LETTER REGARDING RESPONSE TO TECHNICAL NOTICE OF DEFICIENCY FOR  
GROUNDWATER COMPLIANCE PLAN APPLICATION AND CLASS 3 MODIFICATION AT  
SWMU 1, 183, 3, 4, AND BUILDING 8 NAS CORPUS CHRISTI TX  
06/10/2008  
TETRA TECHNUS, INC.

**Subject: Response to Technical Notice of Deficiency  
Naval Air Station Corpus Christi, Corpus Christi, Texas  
Hazardous Waste Permit No. HW-50038  
Industrial Solid Waste Reg. No. 30479  
EPA Identification No. TX7170022787  
WWC No. 12147583; RN 101131332/CN 600621155**

### Response to May 20, 2008 TCEQ Review of the Navy Class 3 Modification, Dated November 2007 for Naval Air Station Corpus Christi (NASCC).

**FIGURE 3**  
**U.S.G.S. TOPOGRAPHIC MAP**  
**GROUNDWATER COMPLIANCE PLAN APPLICATION**  
**NAS CORPUS CHRISTI, TEXAS**

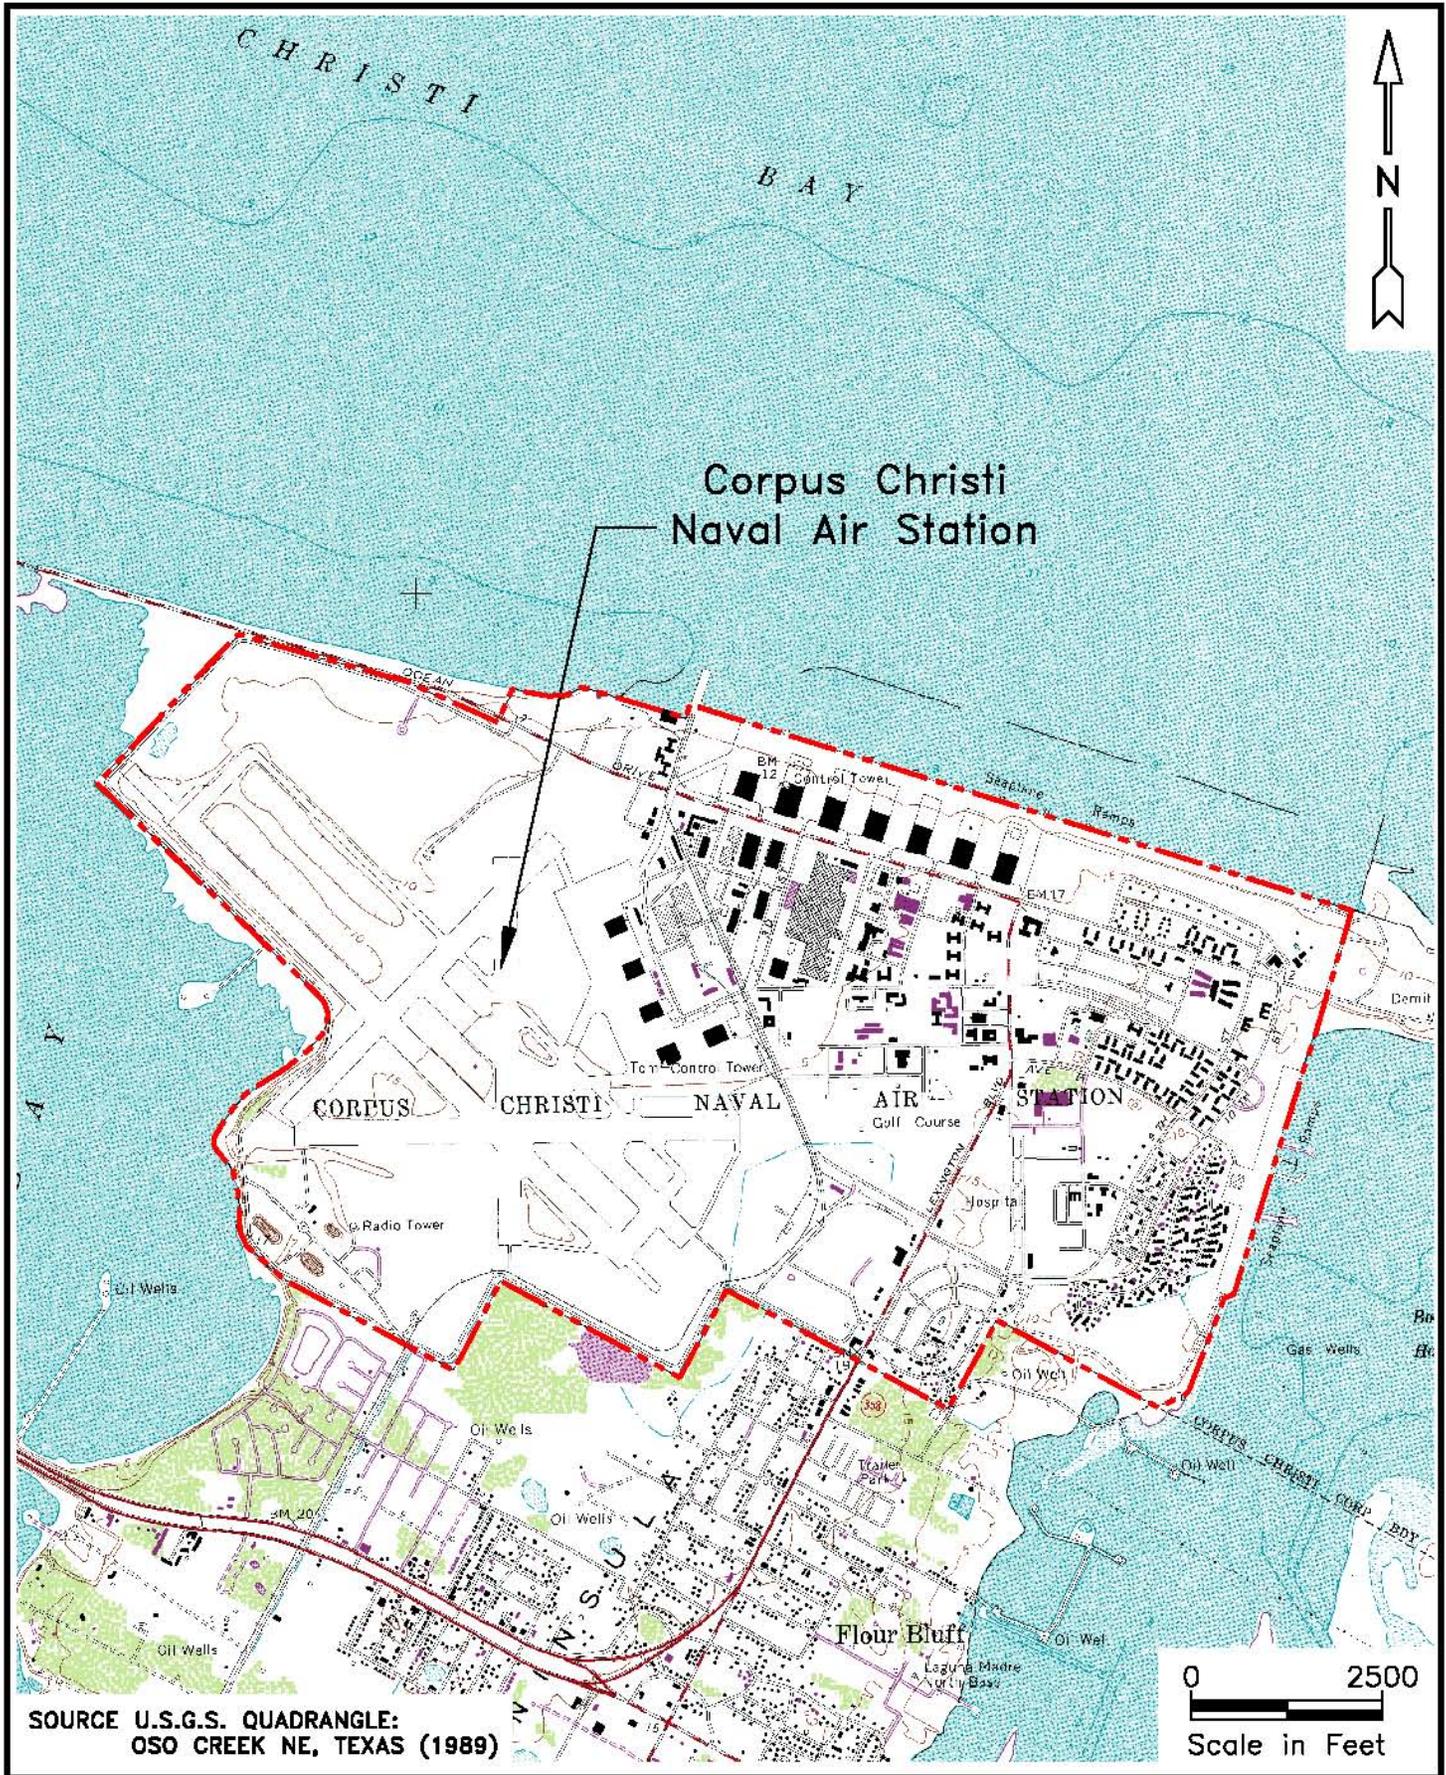
**TCEQ Comment No. 3:** Part II, Section 1.B. – The topographic map required by this section and included as Figure 3 is of poor quality and does not show sufficient detail since it is of such a large scale [1"=3000']. Please provide a map of better quality at a smaller scale that shows greater topographic details of the facility.

**Navy Response:** A revised topographic map has been enclosed to replace the existing Figure 3 in the Compliance Plan Application.

FIGURE 4  
SOLID WASTE MANAGEMENT UNITS  
GROUNDWATER COMPLIANCE PLAN APPLICATION  
NAS CORPUS CHRISTI, TEXAS

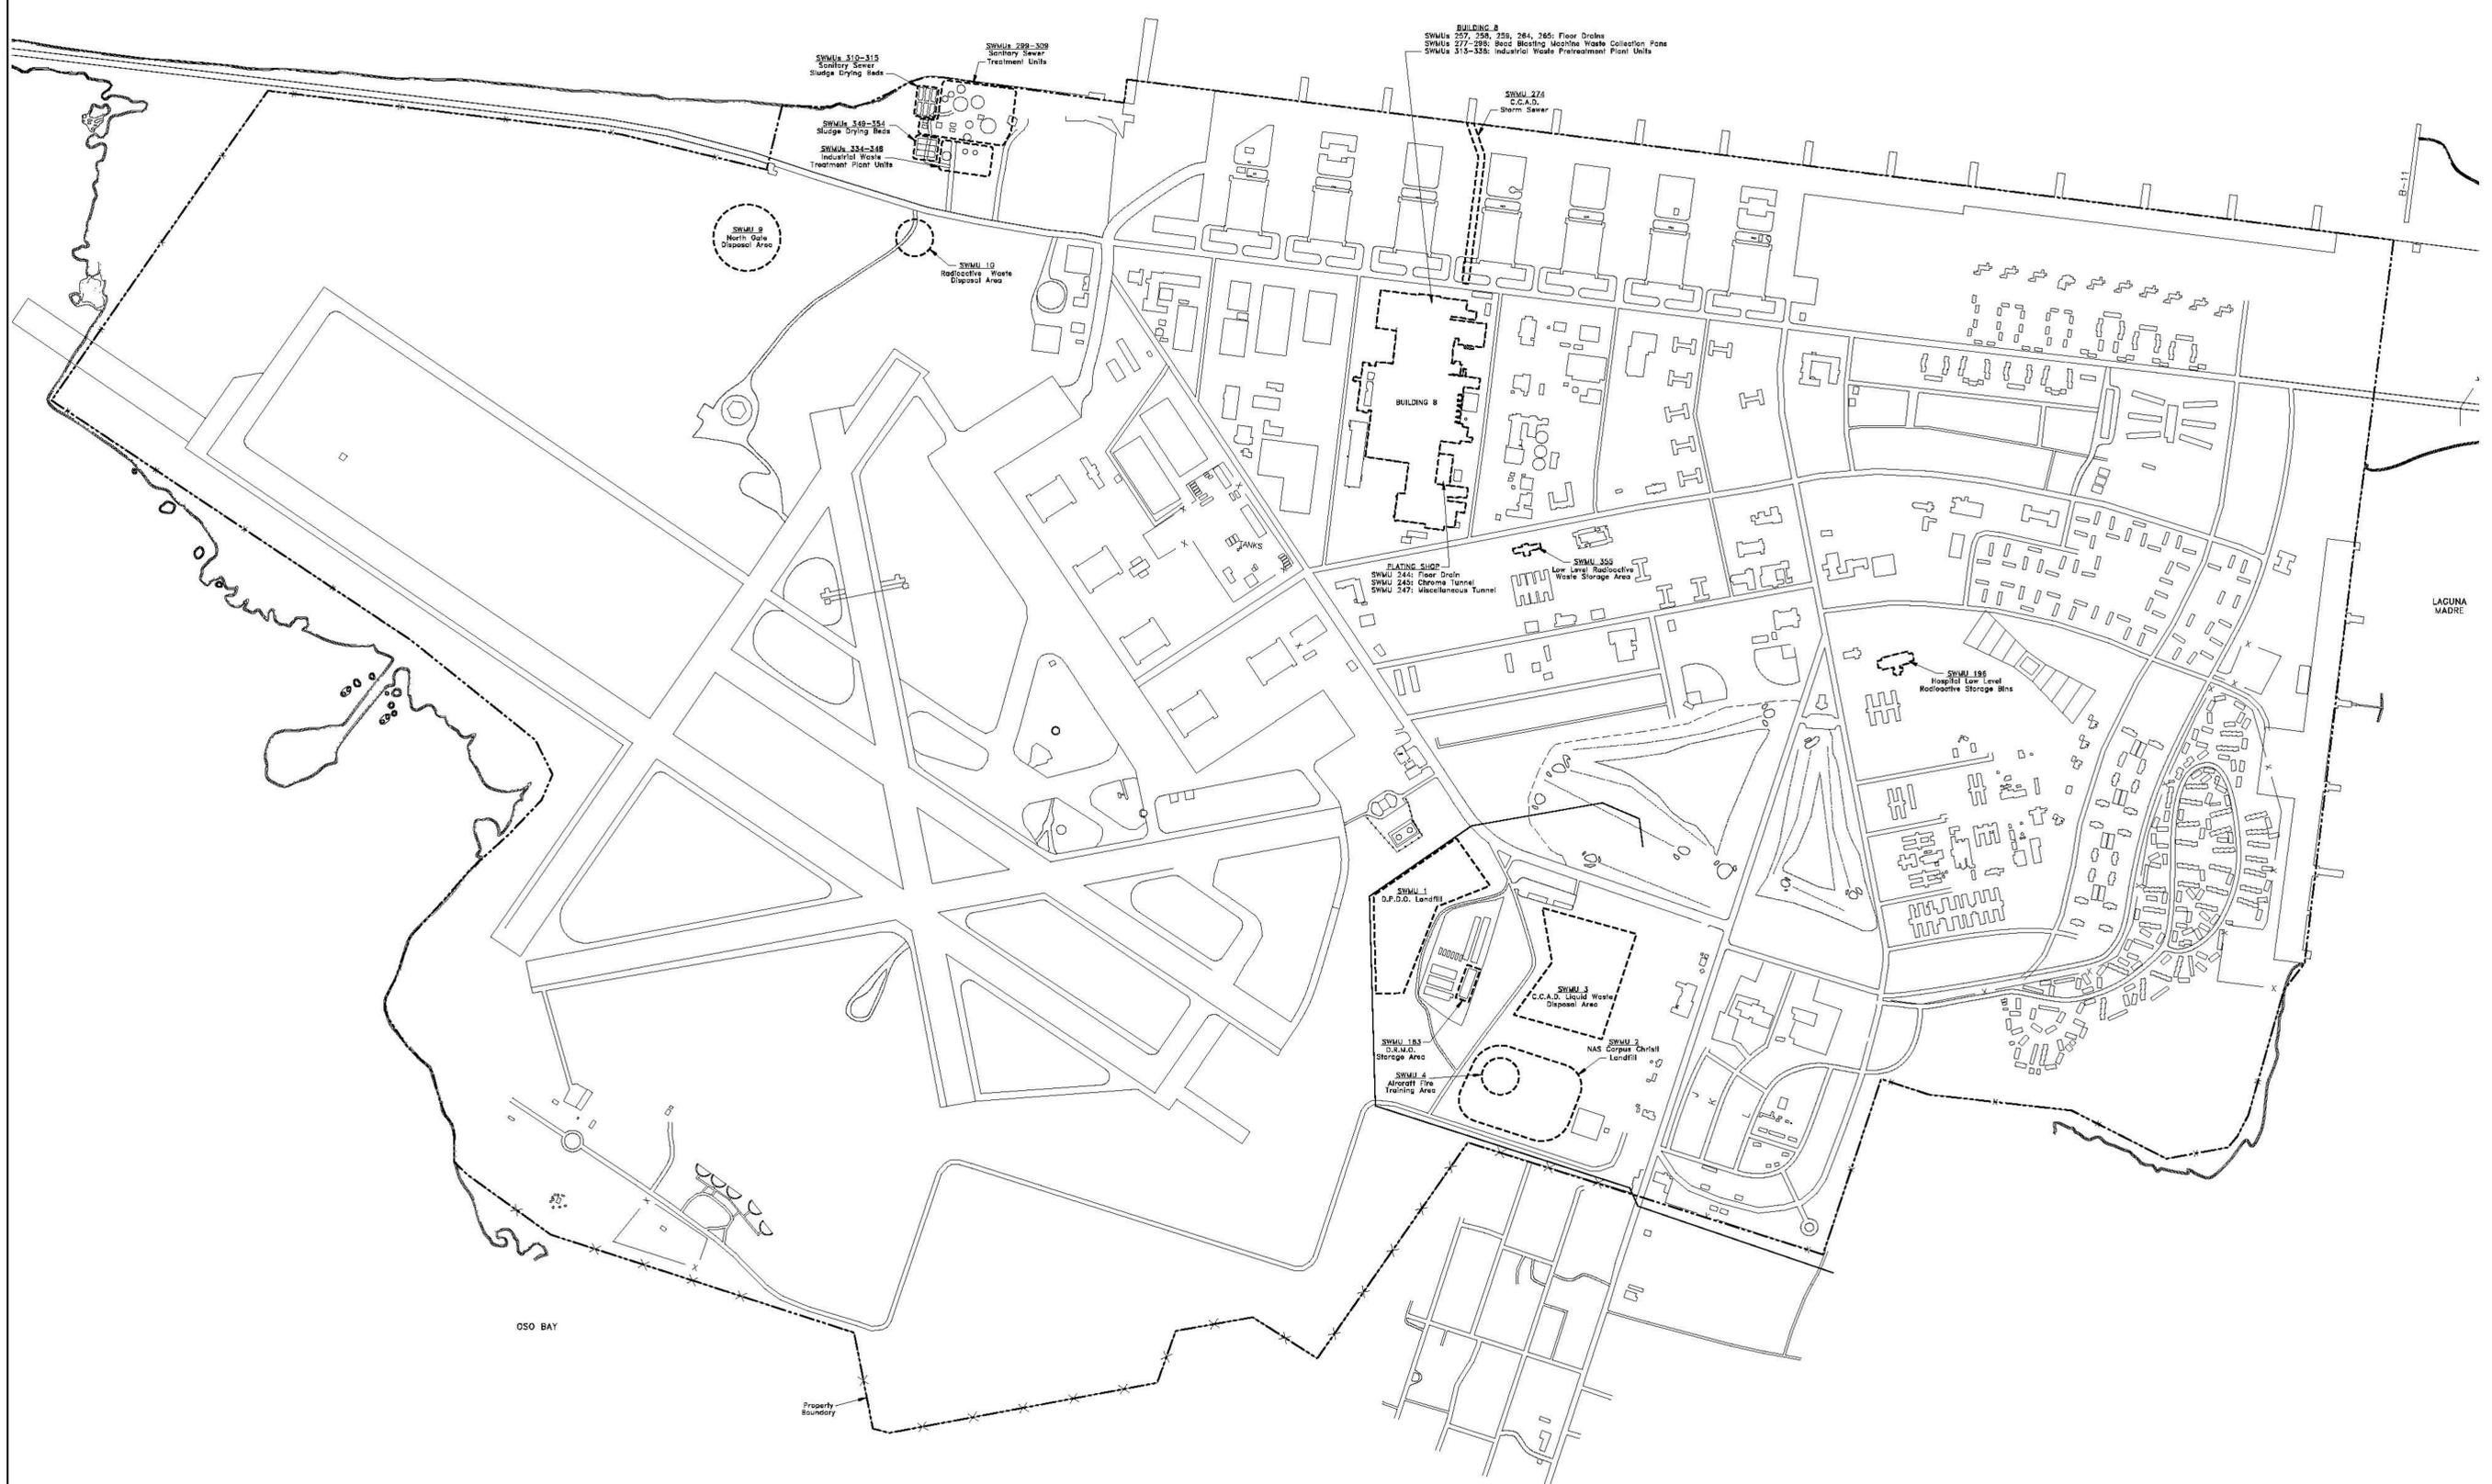
**TCEQ Comment No. 6:** Please submit a solid waste management unit location map for inclusion in Attachment A of the draft compliance plan. If available, an electronic version of the map would be very helpful.

**Navy Response:** Figures 4 (entire site), Figure 5 (SWMU's 1, 2, 4 and 183), and Figure 6 (Bldg 8 ) within the Compliance Plan Application has been corrected to reflect updated information. A revised copy of all figures has been enclosed for replacement in the Compliance Plan Application.
